Intel[®] StrongARM^{*} SA-1110 Microprocessor

Specification Update

April 2001

Order Number: 278259-022

Figure 9-2. Interrupt Controller Block Diagram

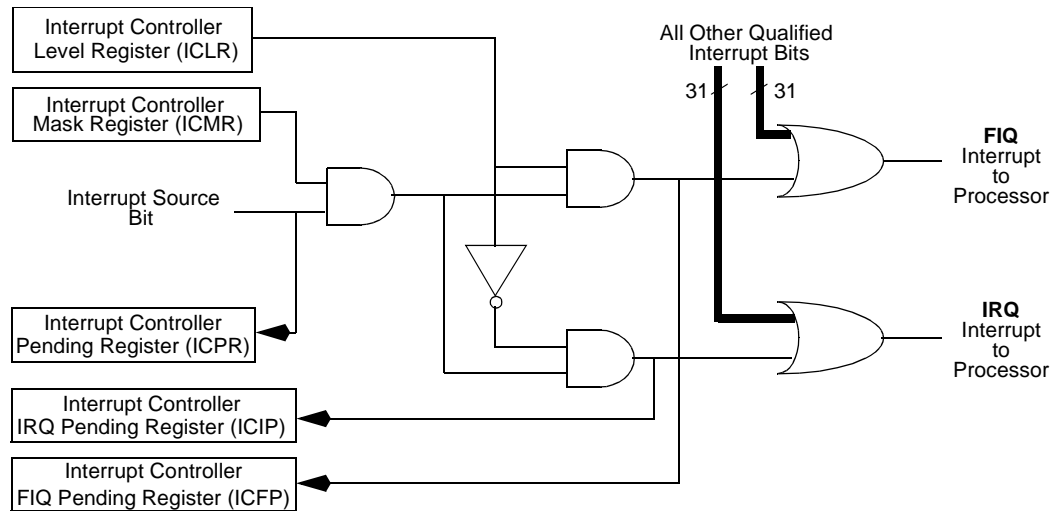
Made the following changes to Figure 9-2.

- Changed Interrupt Level Register to Interrupt Controller Level Register (ICLR)
- Changed Interrupt Mask Register to Interrupt Controller Mask Register (ICMR)
- Changed Interrupt Pending Register to Interrupt Controller Pending Register (ICPR)
- Changed IRQ Interrupt Pending Register to Interrupt Controller IRQ Pending Register (ICIP)
- Changed FIQ Interrupt Pending Register to Interrupt Controller FIQ Pending Register (ICFP)

51. DMA Device Address Register (DDARn): Section 11.6.1.1

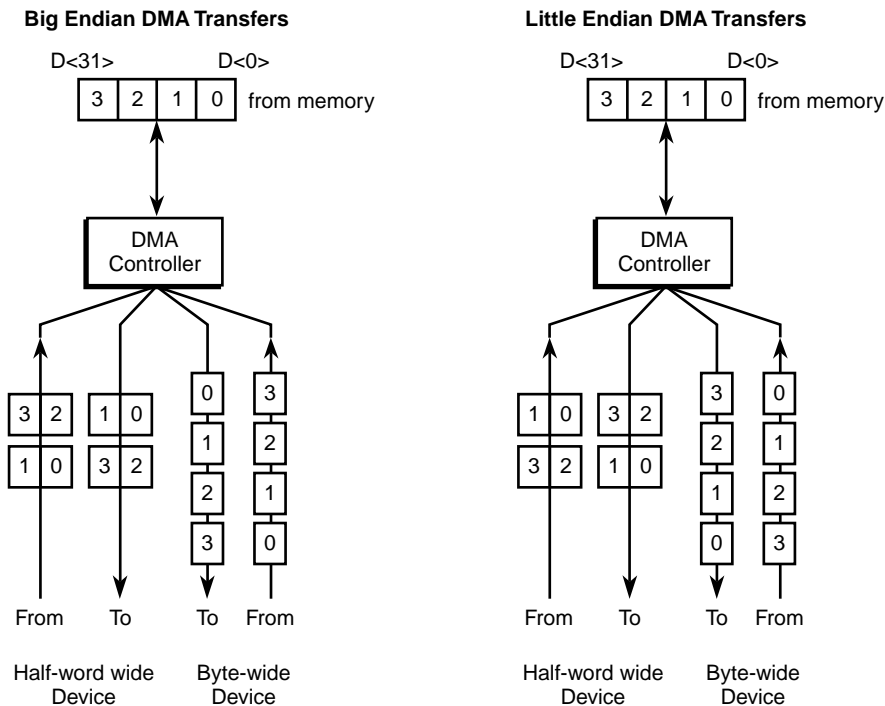
Corrected Figure 11-2.

58. DMA Buffer B Transfer Count Register (DBTBn): Section 11.6.1.6

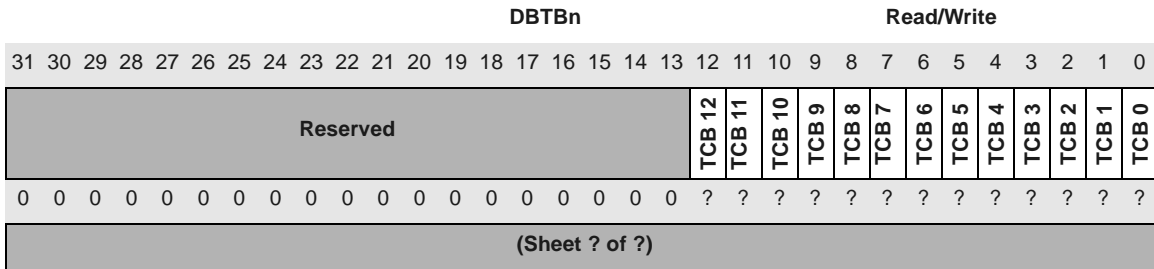
Change the DMA buffer B transfer count register description in the table from transfer count is 8 Kbyte. to transfer count is 8191 bytes.

Changed DMA Buffer B Transfer Count register reset values for the Reserved bits to 0.

Bits	Name	Description
12..0	TCB 12..0	Transfer count (buffer B). This field is a 13-bit value and contains the current transfer count (in bytes) for the transfer to or from buffer B. The maximum value programmed via this transfer count is 8191 bytes.
31..13	—	Reserved. These bits are reserved and read as zeros. Writes to this field have no effect.

Figure 11-10. Passive Mode Beginning-of-Frame Timing

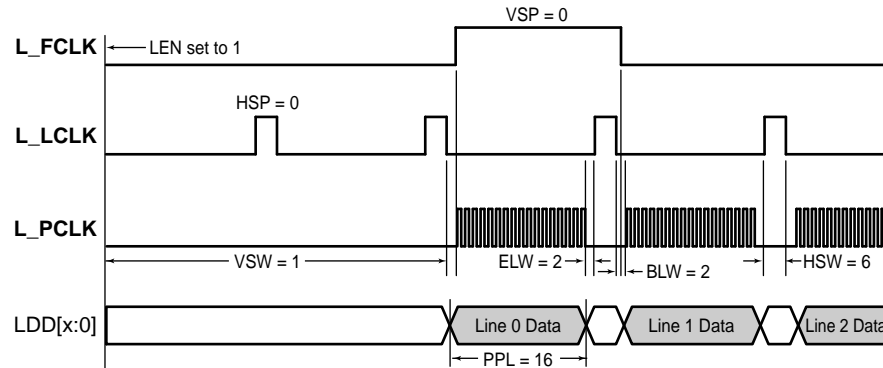
Changed the Notes: in Figure 11-10 to show the range of HSW as 1 to 64, not 0 to 64. The corrected figure is shown below:

Figure 11-11. Passive Mode End of Frame Timing

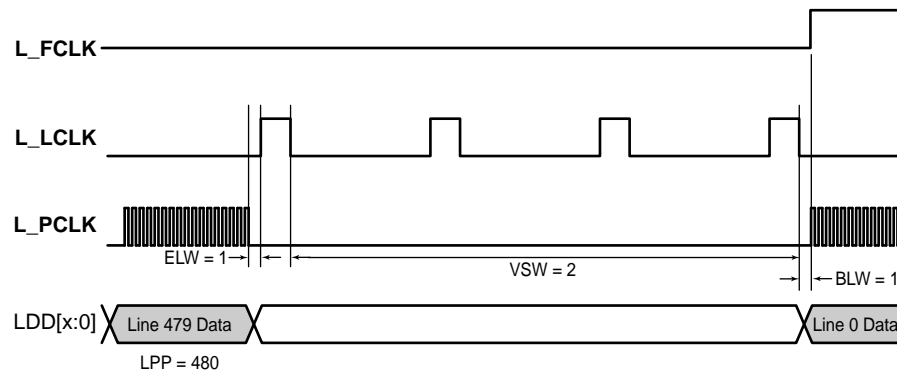
In Figure 11-11 at the location where L_LCLK is deasserted just prior to Line 0 Data, there are two vertical bars depicting BLW = 1. Extended the right vertical bar upward to near L_LFCLK. At this point, changed L_FCLK to show a transition from deasserted to asserted (shown below.)

Also, changed the Notes: in Figure 11-11 to show the range of BLW as 1 to 256, not 0 to 256. The corrected figure is shown below:

Figure 11-13. Active Mode Timing

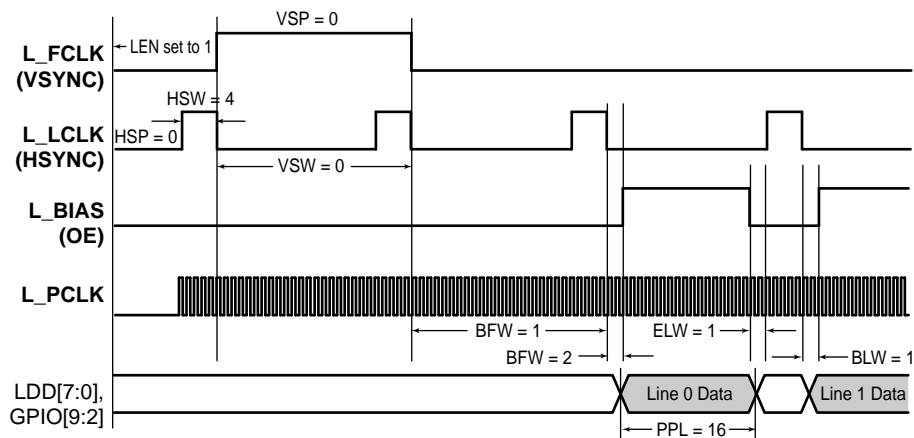
Corrected Notes: in Figure 11-13 to show the range of PPL as 16 to 1024 (not 1 to 1024.) The corrected figure is shown below:
